ECE/TRANS/WP.30/GE.1/200715 22 octobre 2007

Modèle de données douanières pour le transit de l'Organisation mondiale des douanes

Note du secrétariat\*

## WCO/DMPT - TIR DMRs

WCO LOG:	
DATE:	
User reference (*):	TRT_0003
User date:	19.06.2007

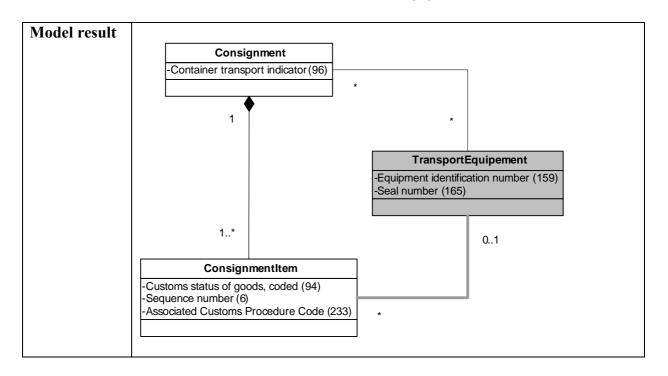
Originator (*):		DMPT_TRT
Cont	tact person (*):	André Sceia
Ema	il (*):	andre.sceia@unece.org
Phon	ne (*):	+41 22 917 13 13
Data	set (*):	TRT
Attac	ched	-
Docu	ımentation	
Busin Need (*):	ness l/Justification	A TIR transport can have multiple loading points. The goods manifest in the TIR Carnet mentions the <b>Customs office(s) of departure</b> . The current transit data model does not allow for declaring this information.
	What process? (*)	TIR Procedure
	For what purpose?(*)	The TIR procedure allows for multiple loading and unloading points in the course of the same TIR transport. The transport operator is therefore requested to declare if goods have different departures.
	Based on?	TIR Convention 1975
	Example.	A TIR transport begins in Geneva (Switzerland) with 10 boxes of chocolate and loads 20 additional boxes of candies in Berlin (Germany). All 30 will go to Moscow (Russian Federation).

User reference (*):	TRT_0003
MIG/Model Tag (*):	TRT
Name of MIG/Model	Transit
(*):	
Action (*):	Adding a "TransitDeparture" class would allow providing the
	information on the Customs office(s) of departure. The class should
	be linked with a "0:1" cardinality to the Consignment class.
<b>Terms and Definitions</b>	-

Oper	Posn (*)	Seg (*)/ DE (*)	Segment/ Data element Name (*)	Stat (*)	<b>Rpt</b> (*)	Lvl (*)	Sect
A	-	-	TransitDeparture class	-	-	-	-
Explan	atory	Create an	id use in the TRT model a TransitTranspo	ortMean	class.		
Text			_				
A	-	?	Place of departure of the transit, coded	-	-	-	-
Explan	atory	Include	a "Place of departure of the transit	, codec	l" DE	the	in the
Text		TransitDe	eparture class (use same format and prop	erties as	DE 18	2).	
A	-	-	Relationship	-	0:1	-	-

0:n		
Explan	atory	Add a re	lationship between the TransitDeparture	class ar	nd the (	Consig	nment
Text		class.					
Model	result						
					Declarat	ion	
				claration na			2)
				claration ressage fund			<del>2</del> )
			-De	claration is	suing date	(22)	
				stoms offic			,
			-To	tal gross w	eight (131		. (02)
				mber of se tal number		220)	
				thentificatio		220)	
			-An	nendment o	ode (99)		
						1
